ABILENE RESTORATION  
MINISTRIES, INC.  
2018 BEECH STREET

10-3-2025  
ADDENDUM A  
10-26-2025

ABILENE RESTORATION  
MINISTRIES, INC.  
ABILENE, TEXAS

SECOND FLOOR PLAN - PLUMBING

FIRST FLOOR PLAN - HVAC EQUIPMENT POWER

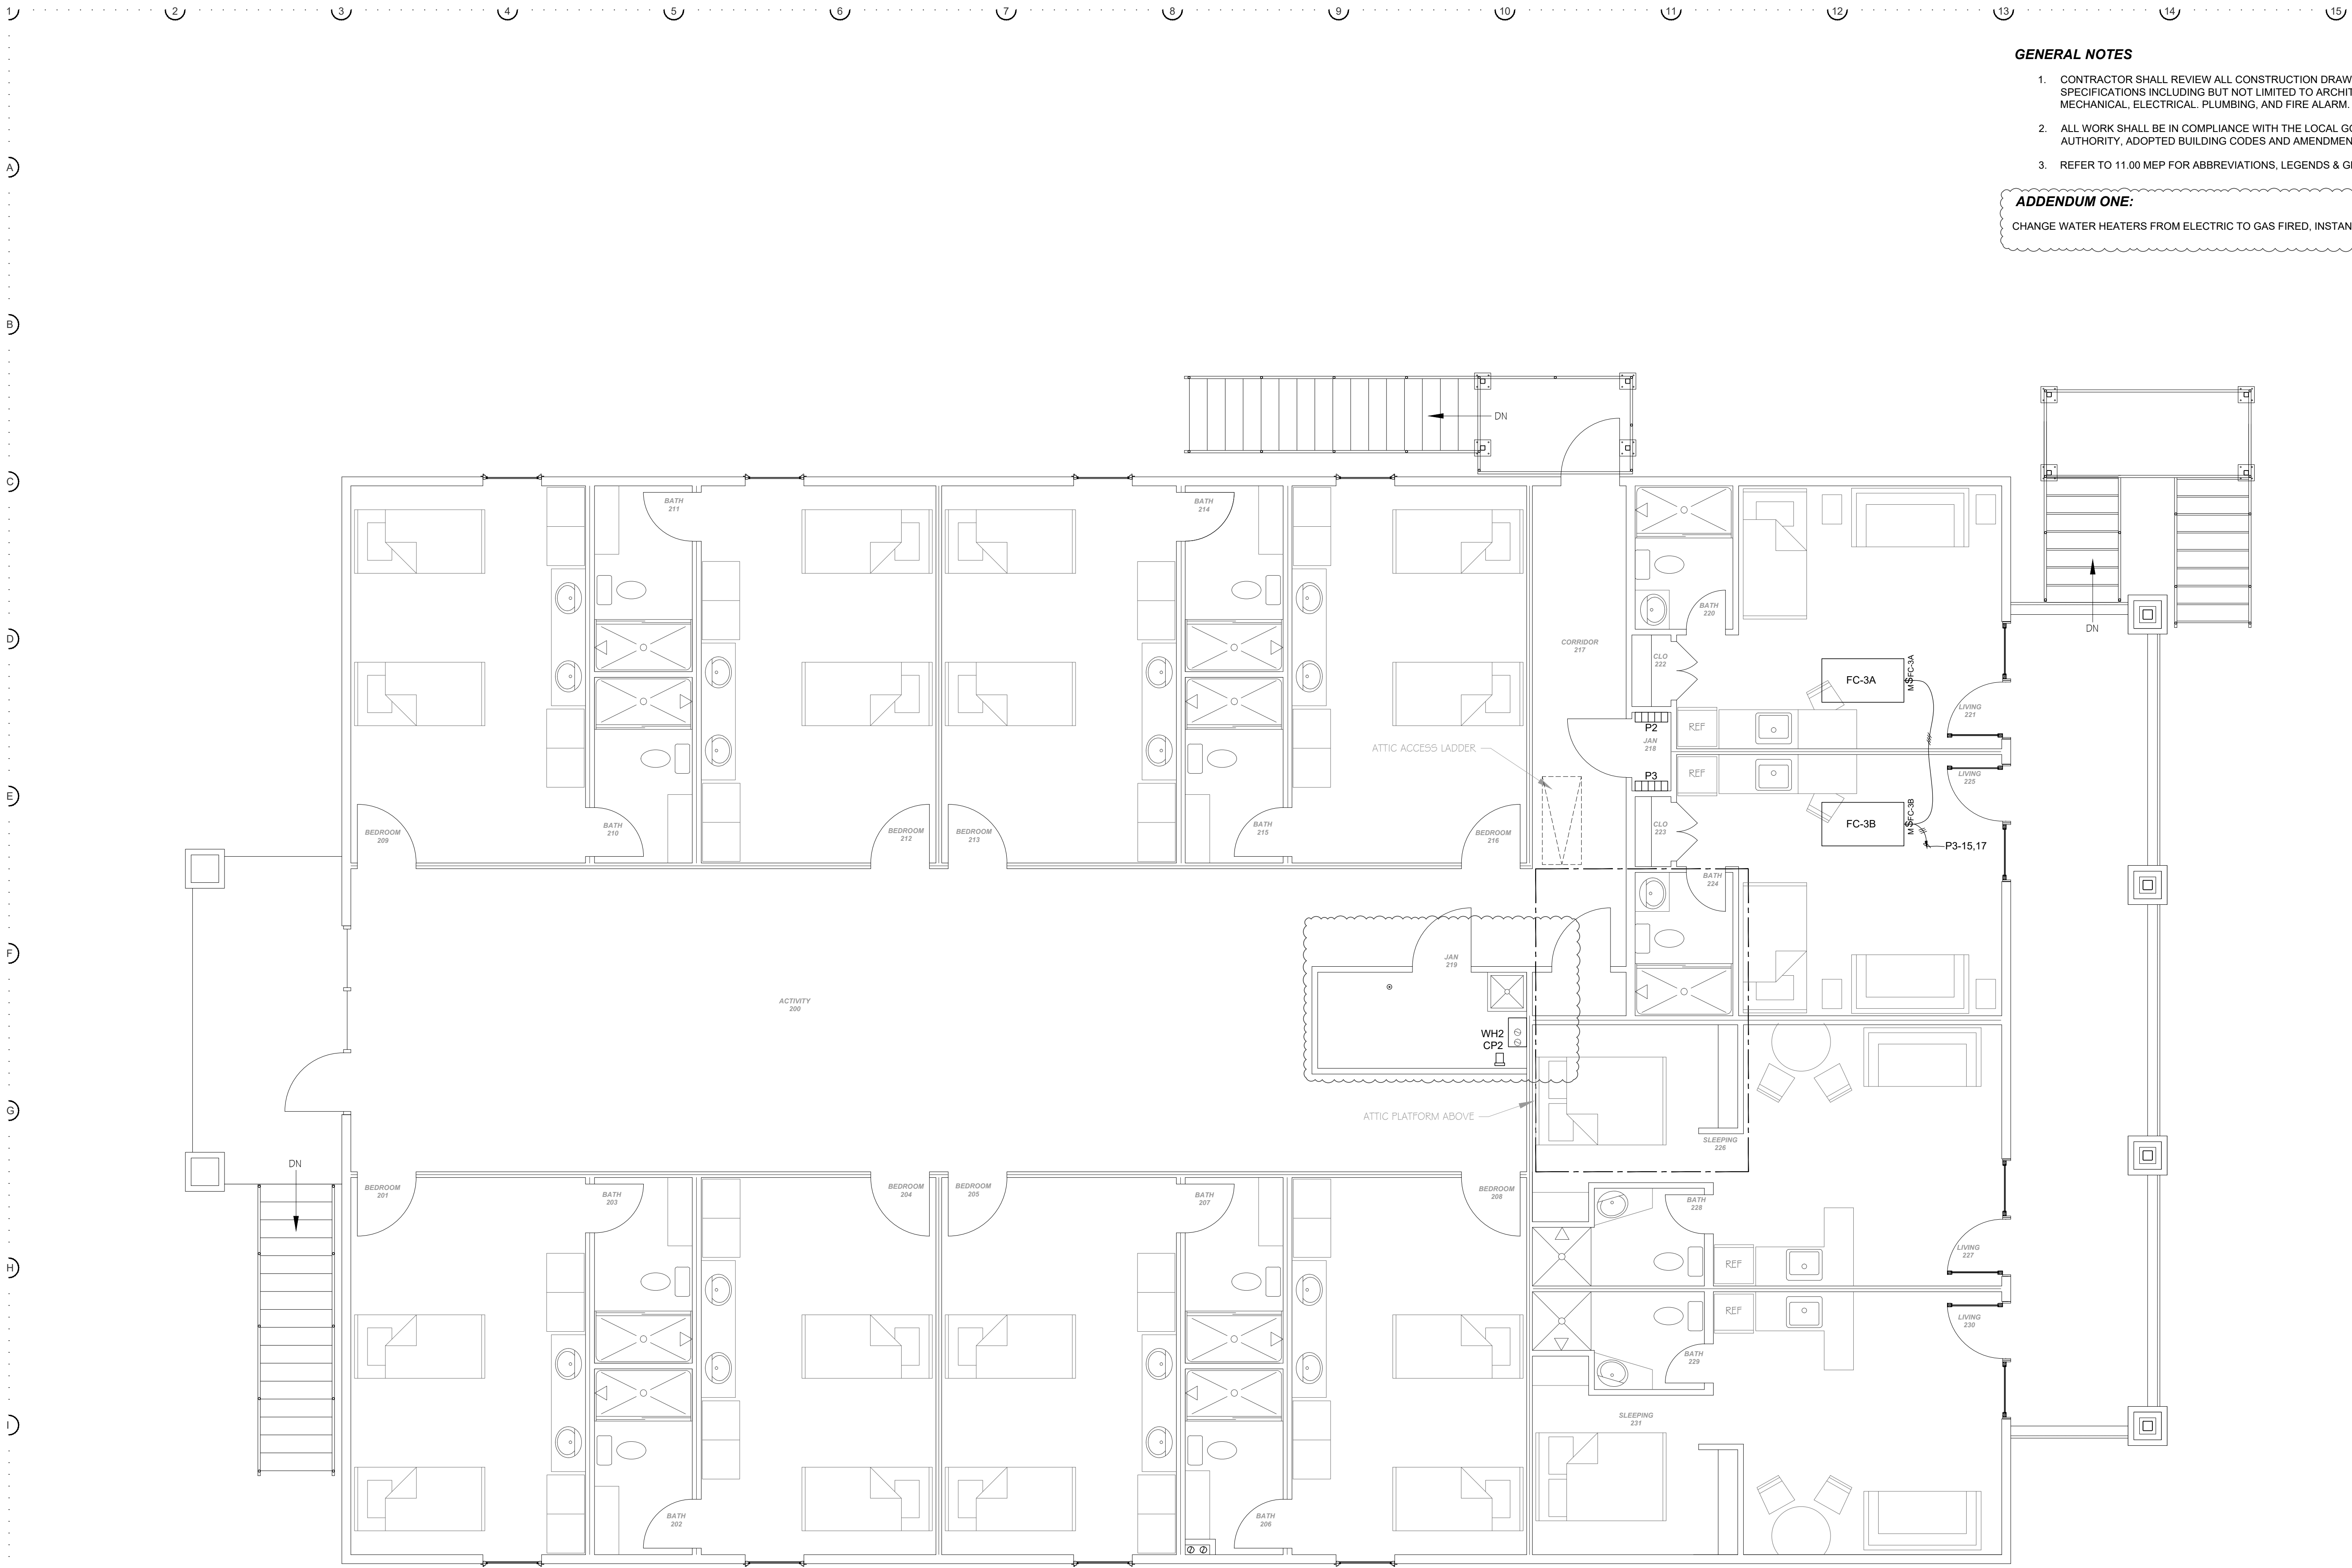
CHANGE WATER HEATERS FROM ELECTRIC TO GAS FIRED, INSTANTANEOUS.  
REVISED GAS PIPE SIZES.

SECOND FLOOR PLAN - HVAC EQUIPMENT POWER

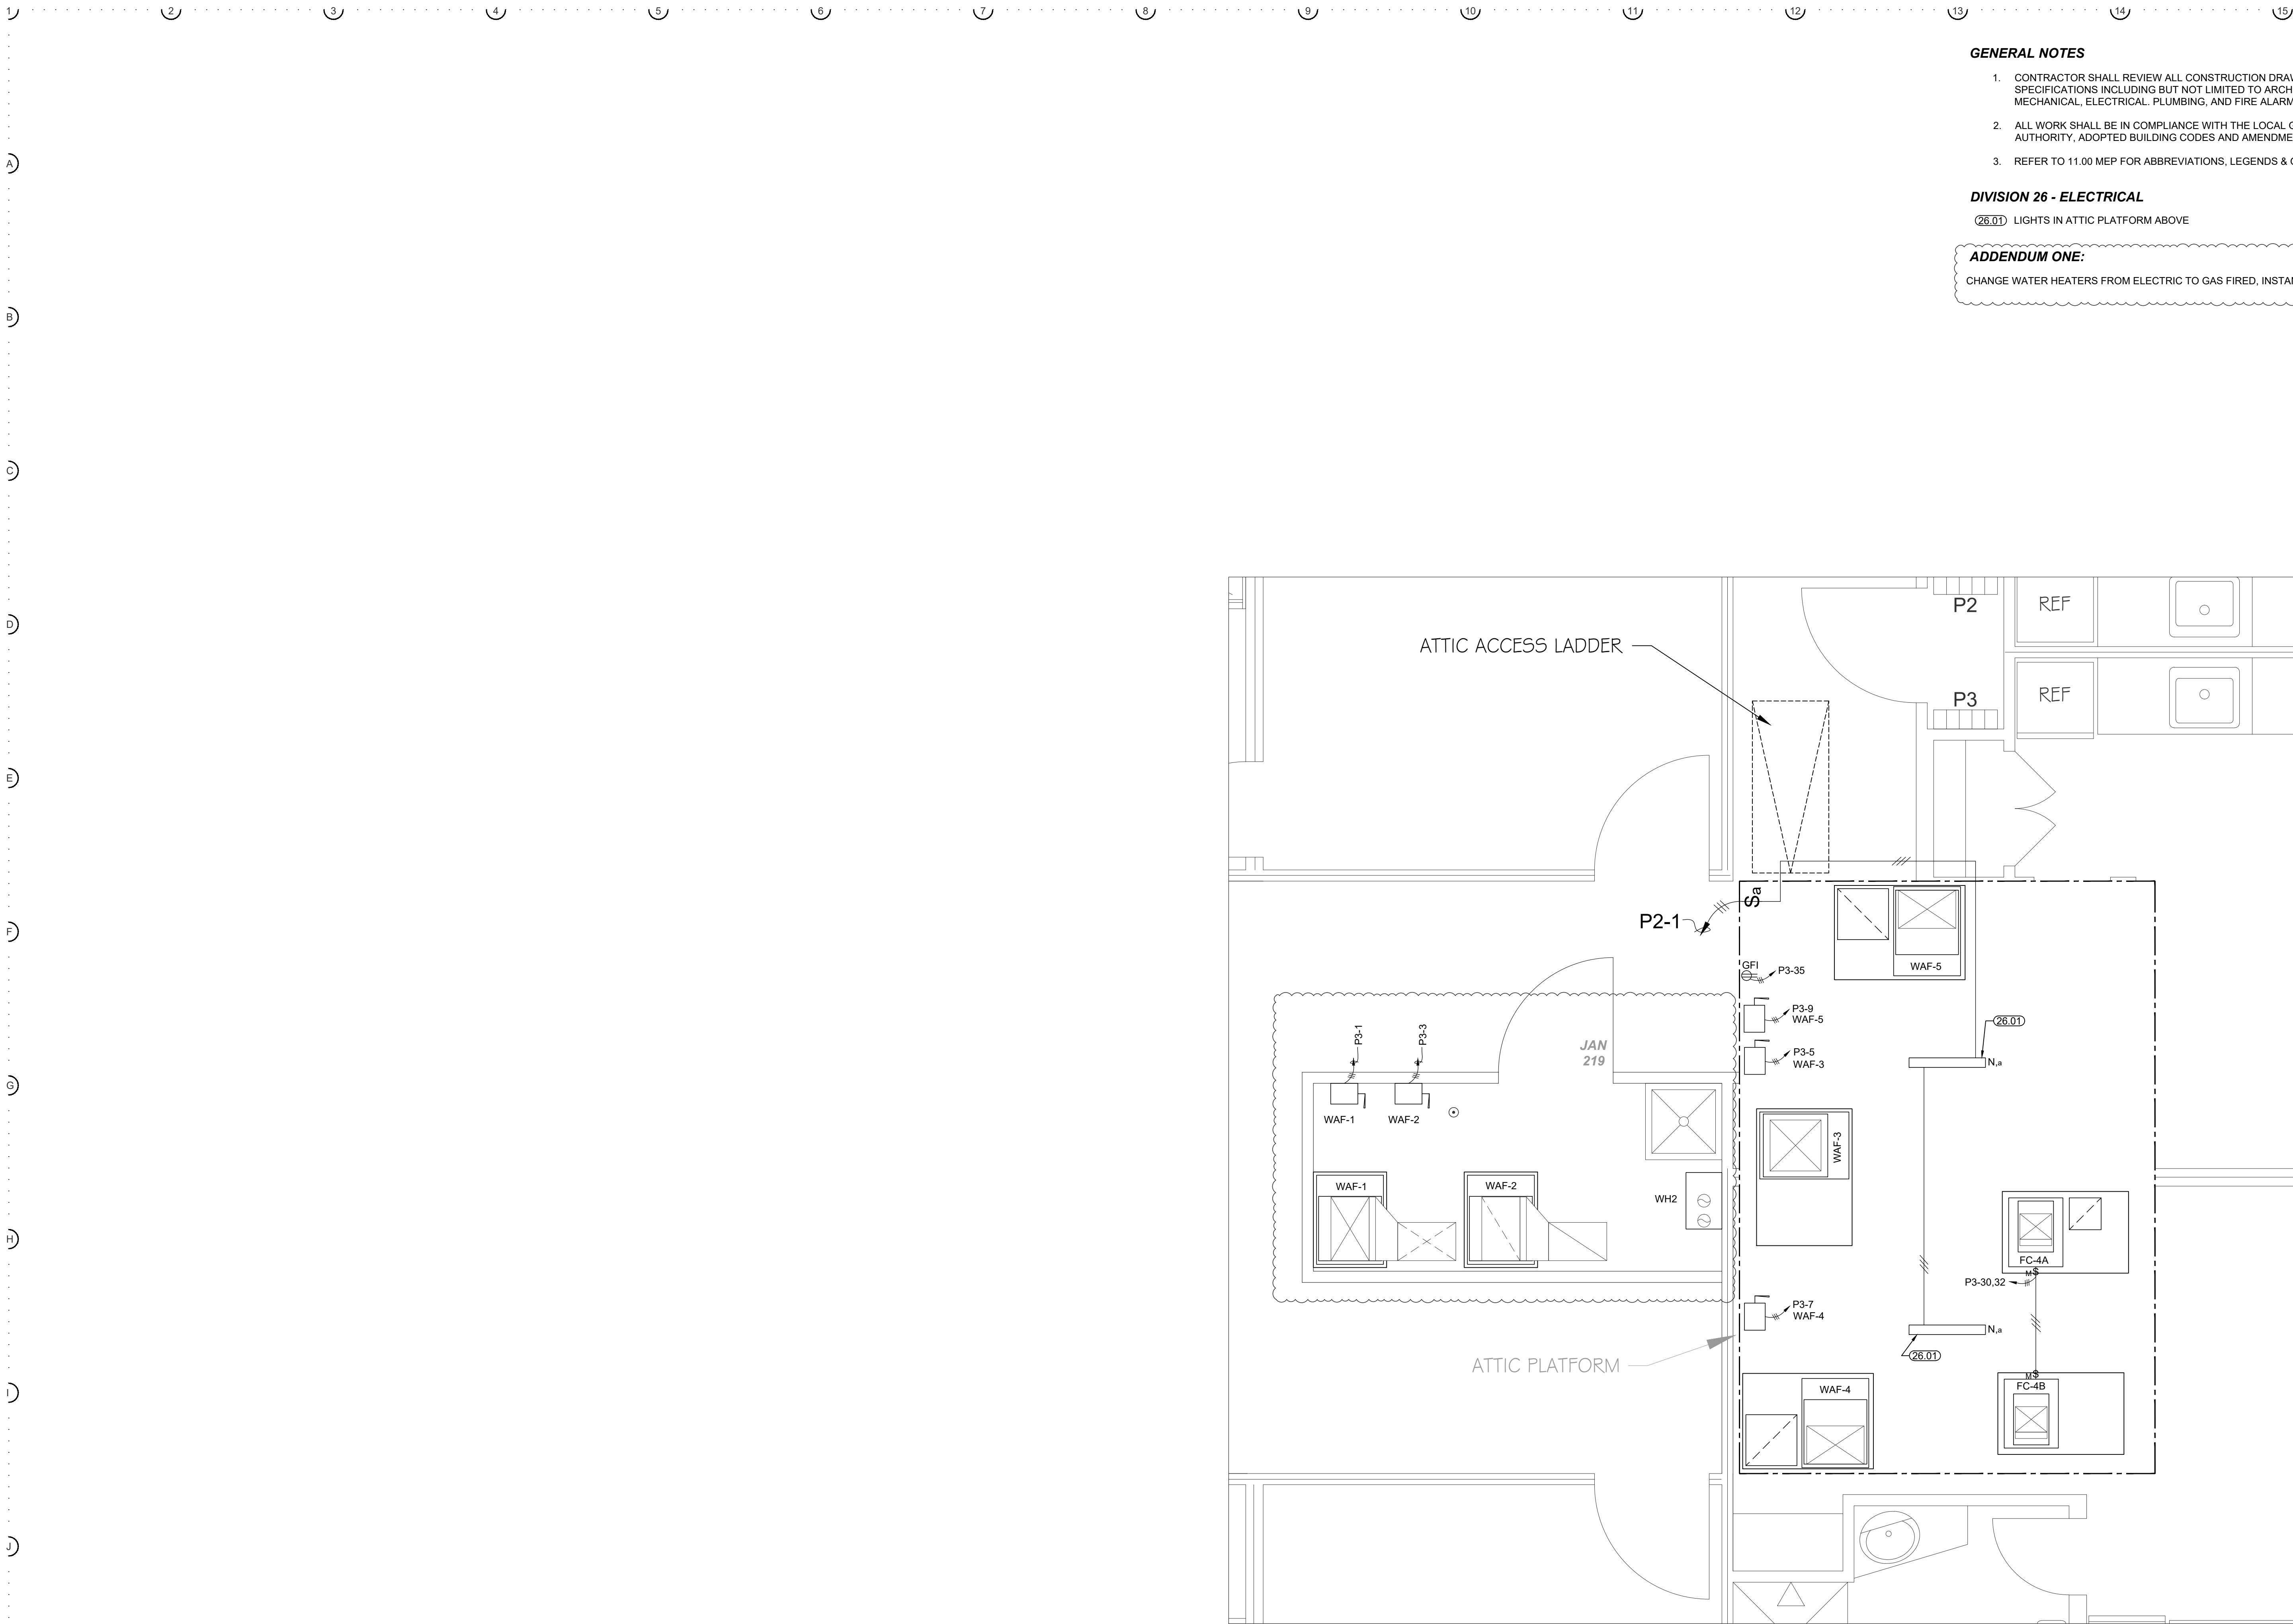
CHANGE WATER HEATERS FROM ELECTRIC TO GAS FIRED, INSTANTANEOUS.
